MINUTES OF THE ACRS THREE MILE ISLAND SUBCOMMITTEE
MEETING
Student Center, Pennsylvania State University Campus
Middletown, PA
June 6-7, 1979

ACRS-1644

The ACRS Three Mile Island Subcommittee met in Middletown, Pa. to discuss details of the Three Mile Island accident with the operators of the plant, Metropolitan Edison and its parent company, General Public Utilities, and with the NRC Staff. The notice of the meeting, containing the proposed agenda, appeared in the Federal Register, p. 29765, Vol. 44 No. 100 Tuesday, May 22, 1979. (Attachment A). The Tentative Detailed Schedule is attached (Attachment B), as well as a list of attendees (Attachment C). Copies of presentation slides and supporting documents are attached as noted below. There were no requests to make oral statements and no written statements received although the Committee had been informed that a Mr. Bar n of Boston, Mass. would submit a statement.

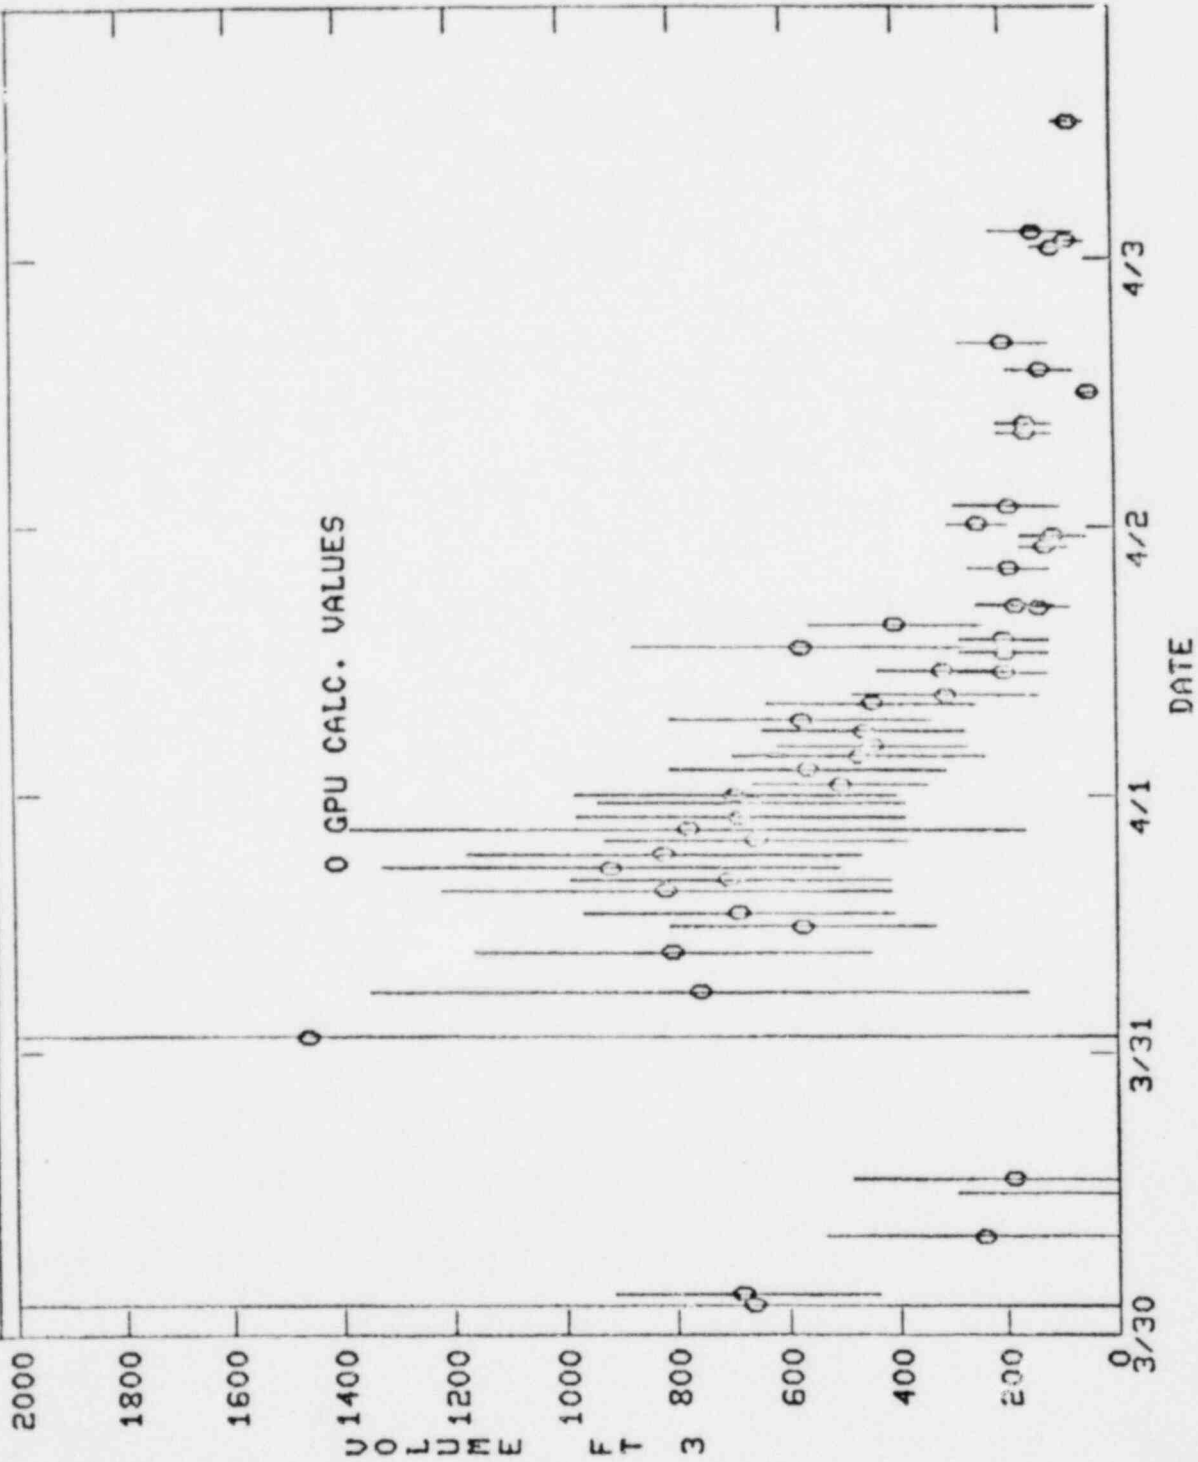
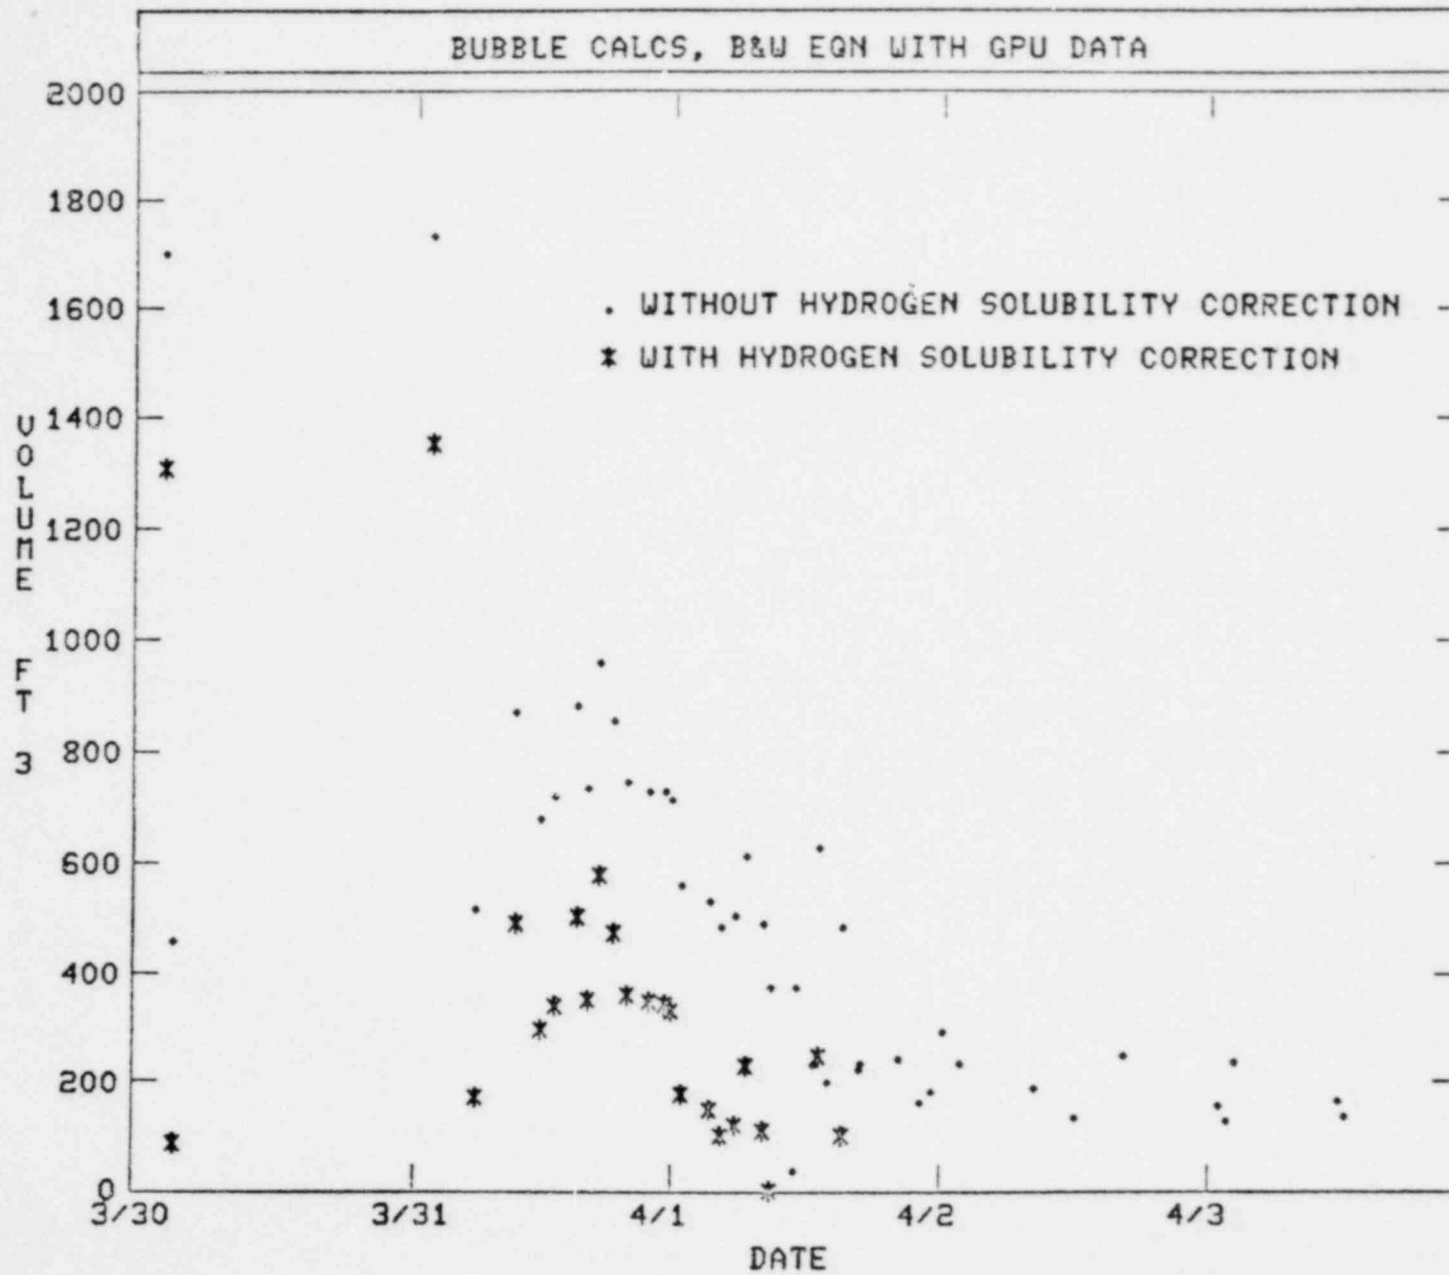
Dr. Lawroski commented that he would have liked more explanatory prose with Attachment D - Evaluation of Hydrogen Bubble Volume in Reactor Coolant System. Mr. Keaten explained that it was meant to show maximum errors possible rather than statistical errors. He agreed to cover it in greater detail at a later time.

THREE MILE ISLAND UNIT 2
 RETRAN TWO LOOP MODEL
 FOR COOLDOWN TRANSIENT
 NODALIZATION DIAGRAM

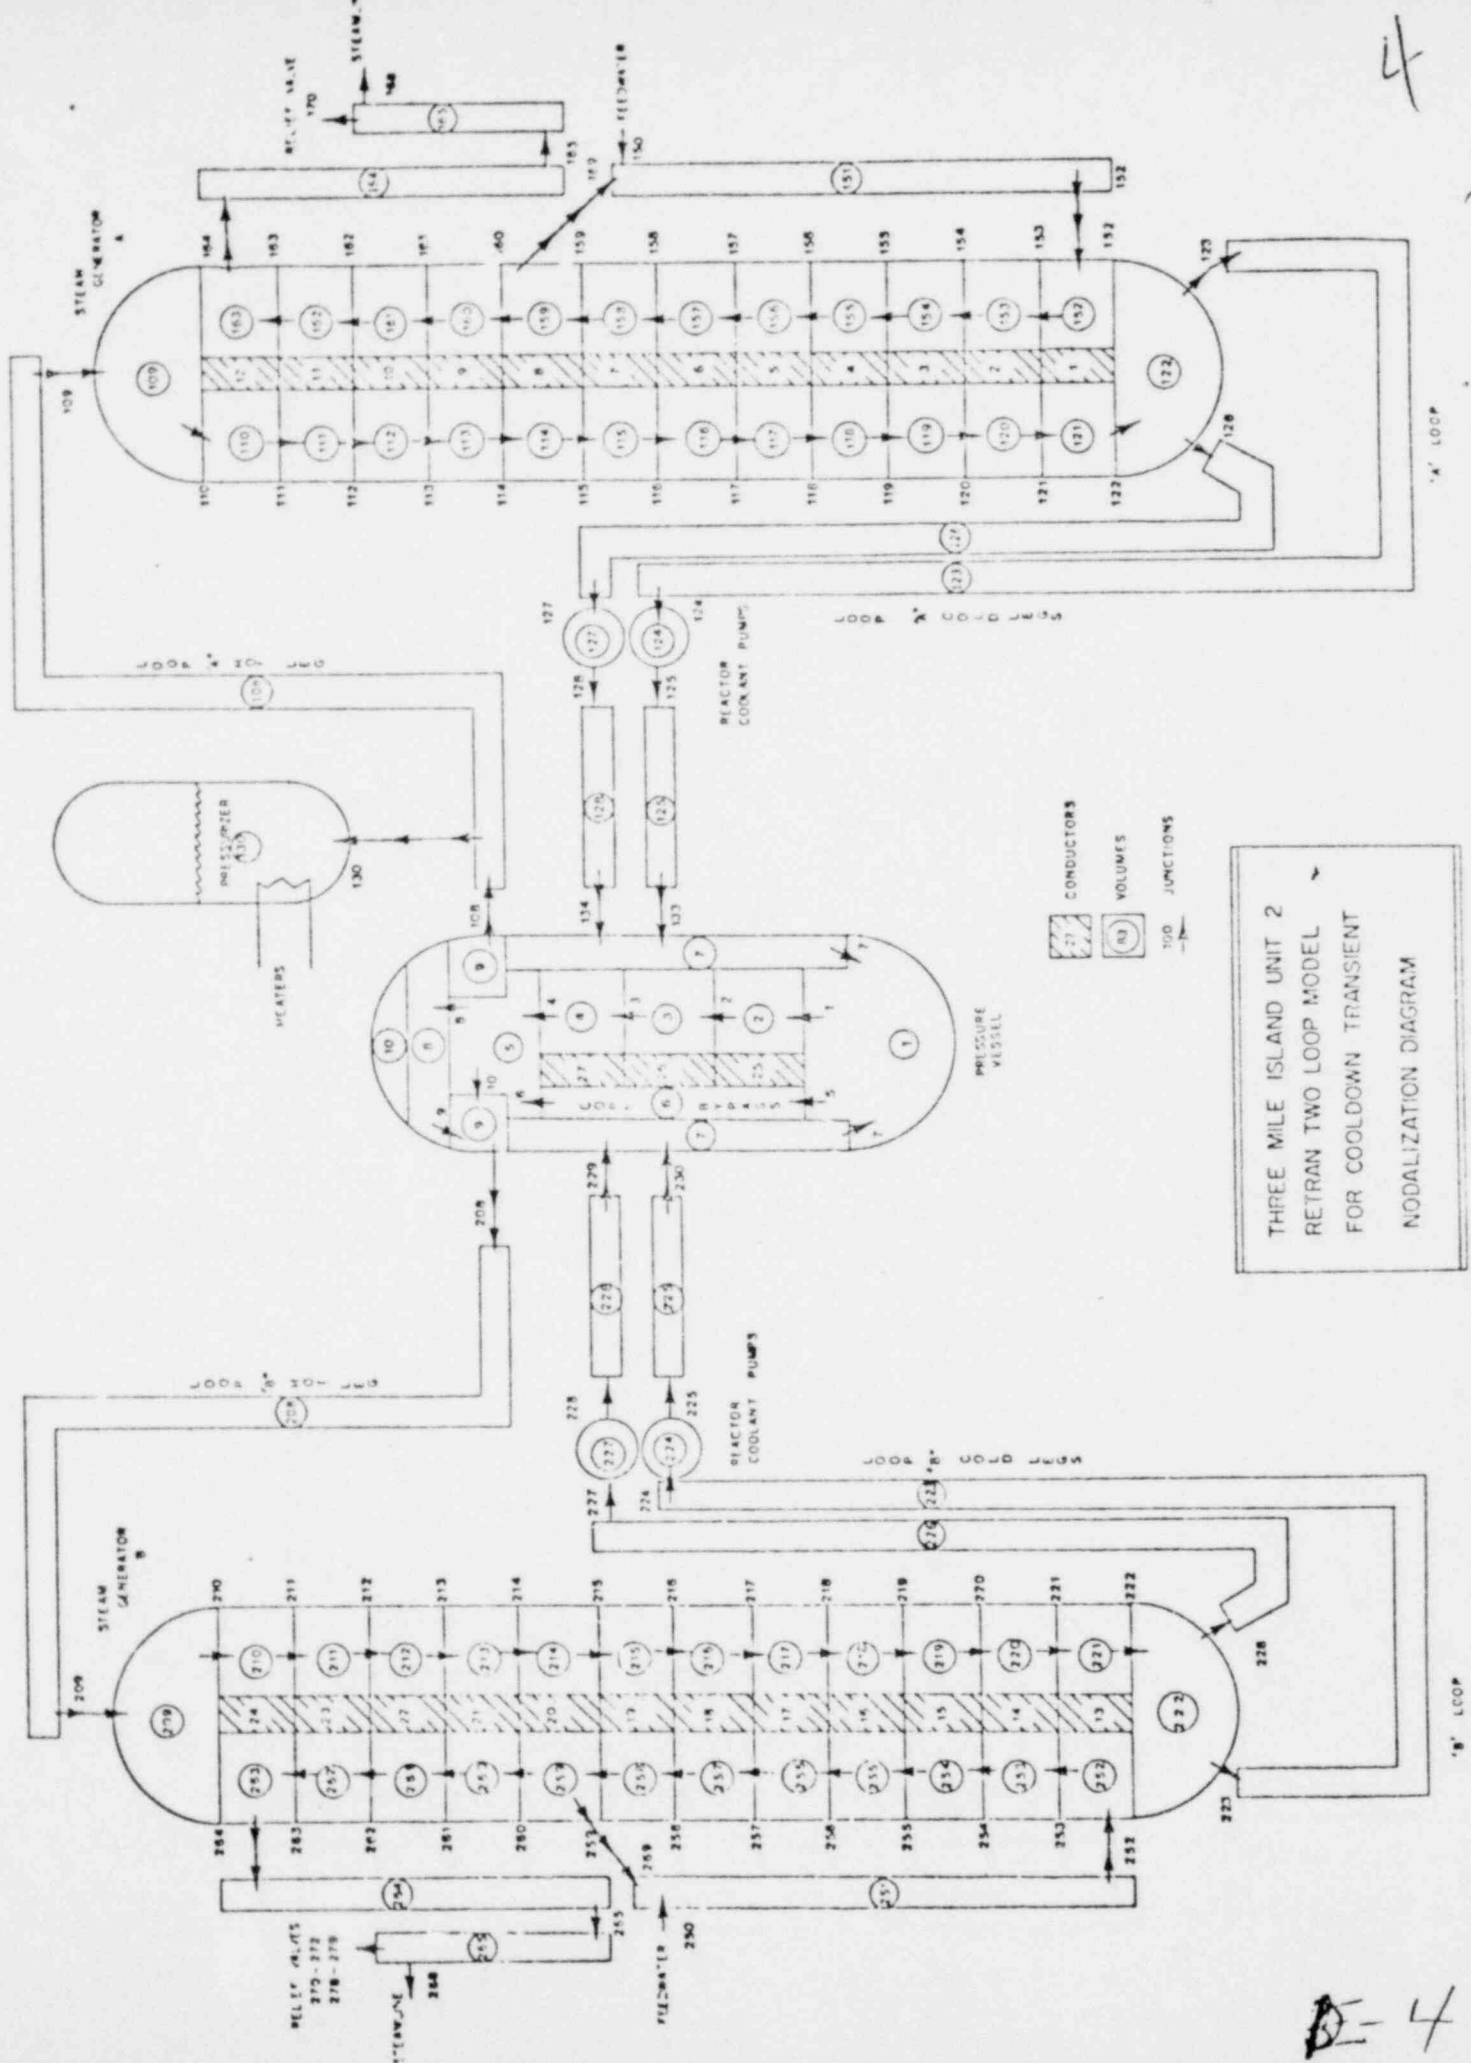
Mr. Keaten discussed Slides E-2 and E-3 and explained the nodalization for the RETRAN code (Slide E-4). In response to Mr. Etherington, he explained that GPU had an independent calculational capability with the aid of Energy, Inc.

INCORE THERMOCOUPLES

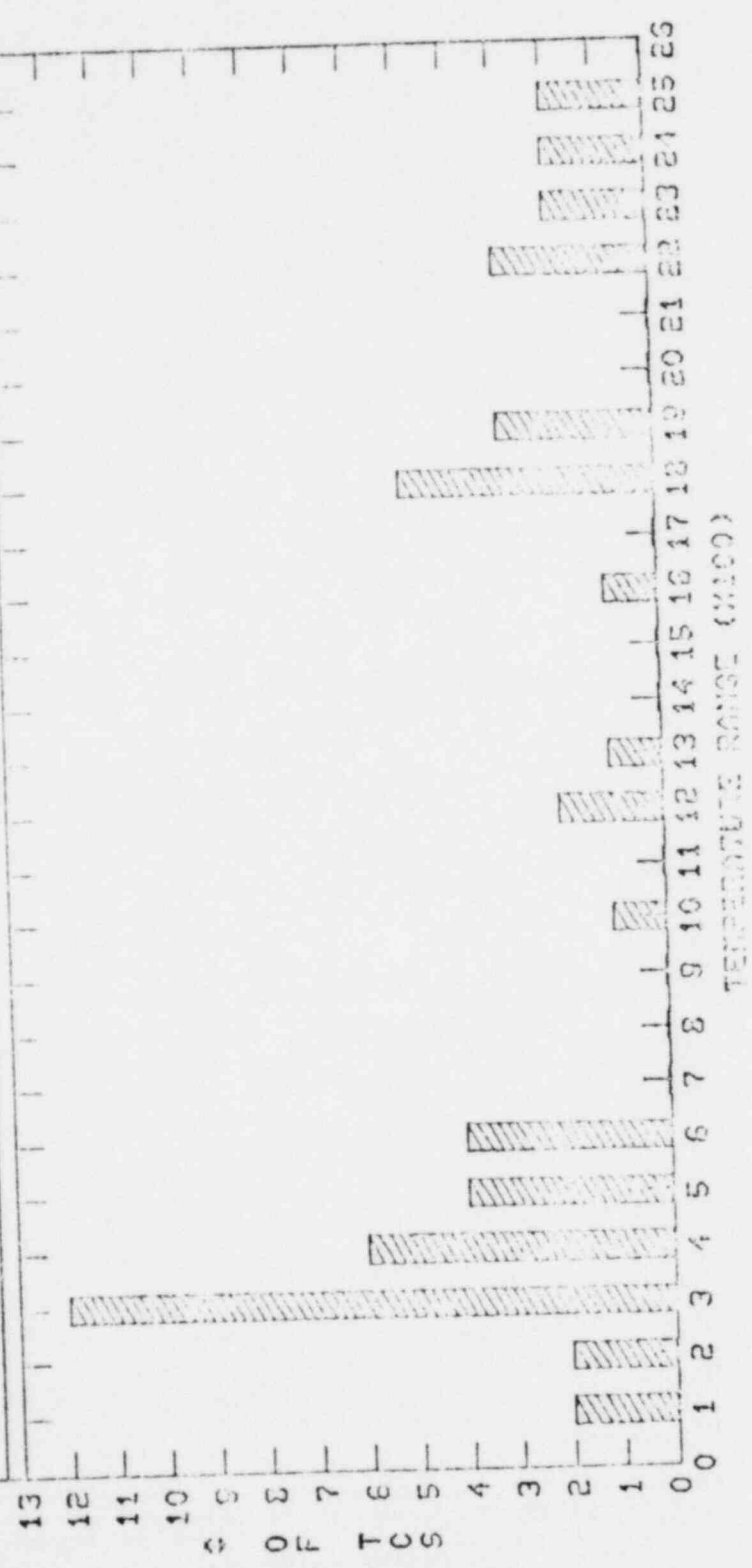
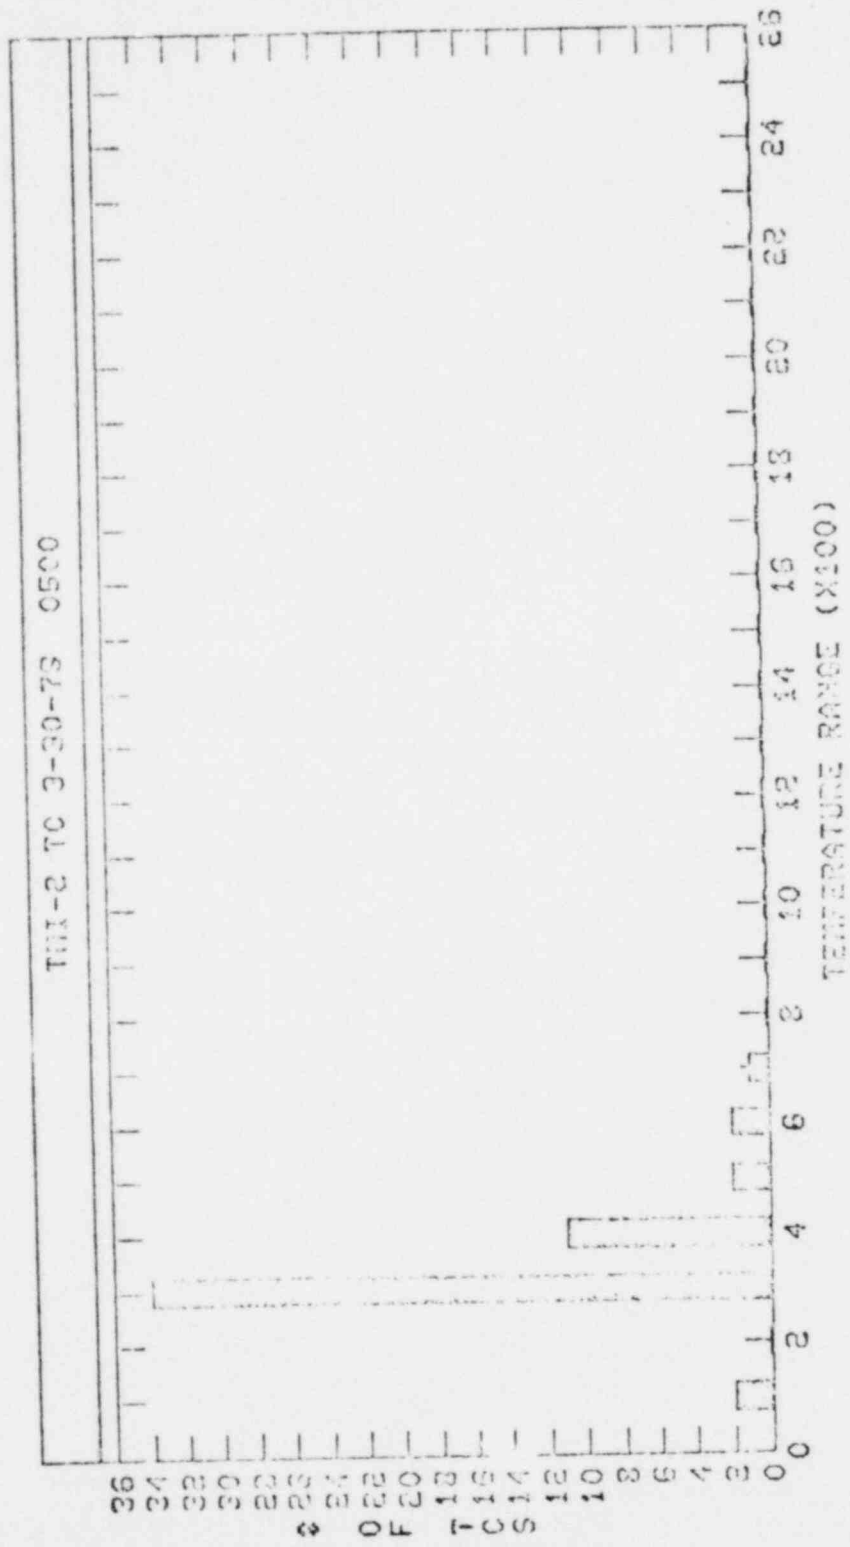
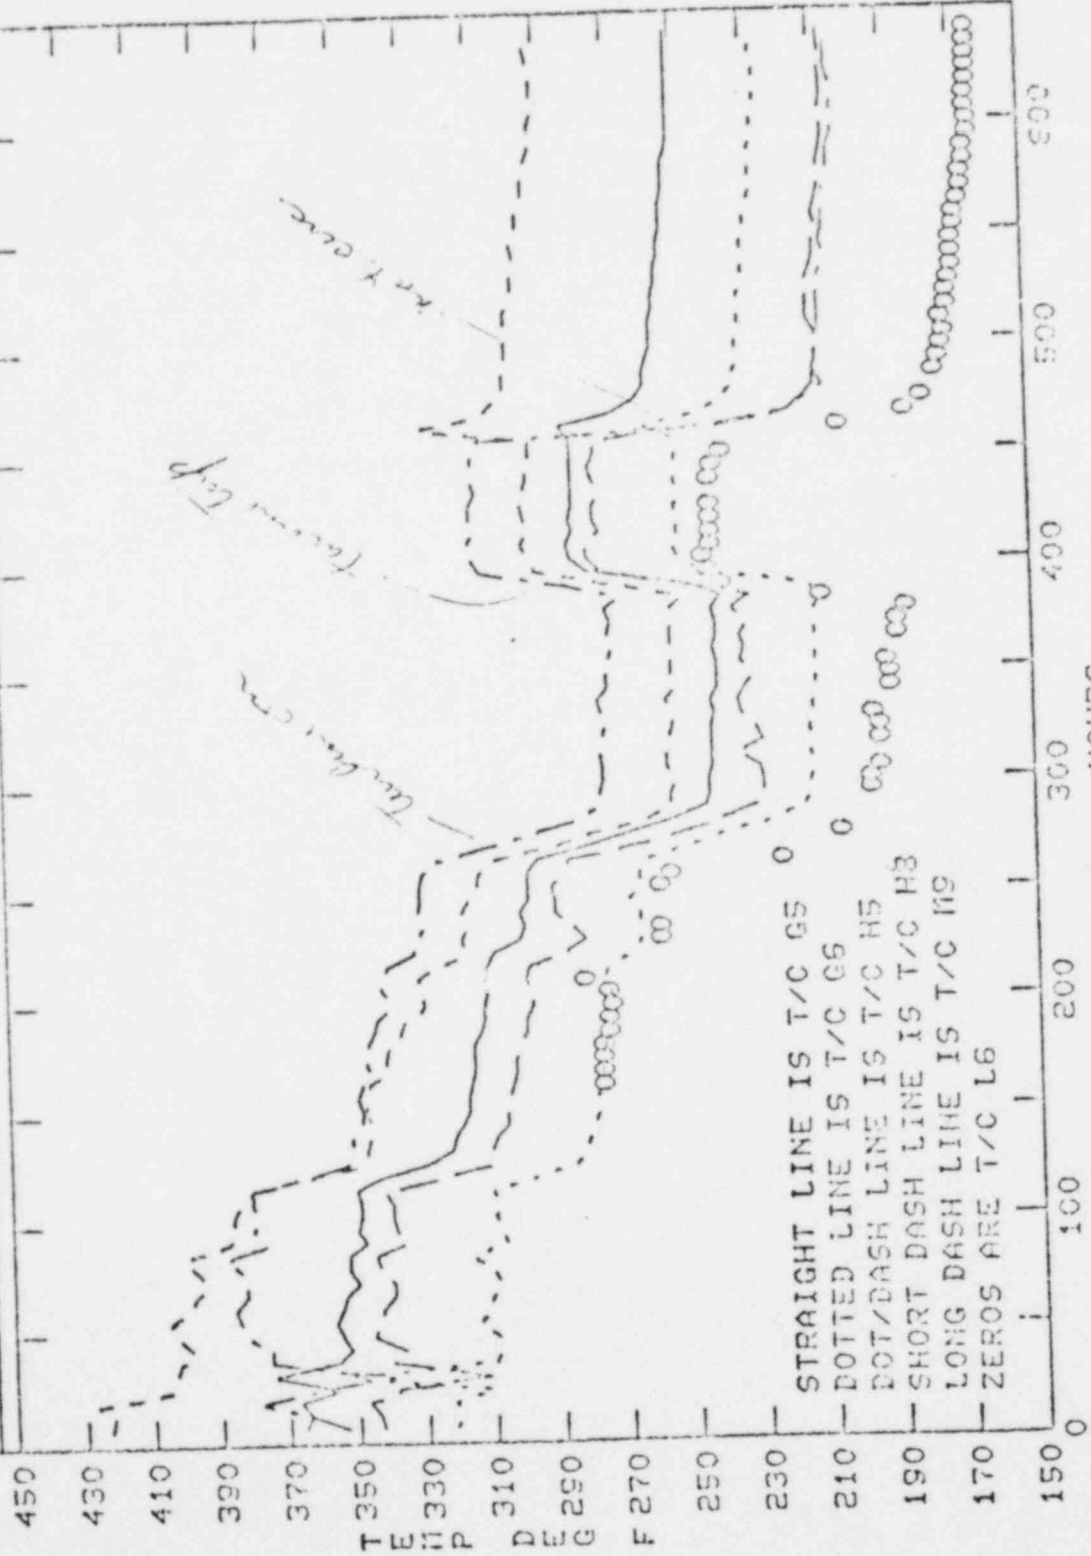
Mr. Keaten discussed thermocouple data with the aid of slides in Attachment F. He pointed out that temperatures over 700° were printed out as question marks by the computer, so a technician had to measure millivolts across the thermocouple terminals. Although some thermocouples had relatively low readings, some were over 1800° . The higher readings were generally near the center of the core. On March 30, all the thermocouples read 700° or less. The ones on the outside read higher than on the 28th, and the ones in the center very much lower.

Mr. Keaten replied to Dr. Carbon's question that Gary Miller had asked for these readings, and he was told that some were high and some low and they were probably not reliable. He never received the complete set.
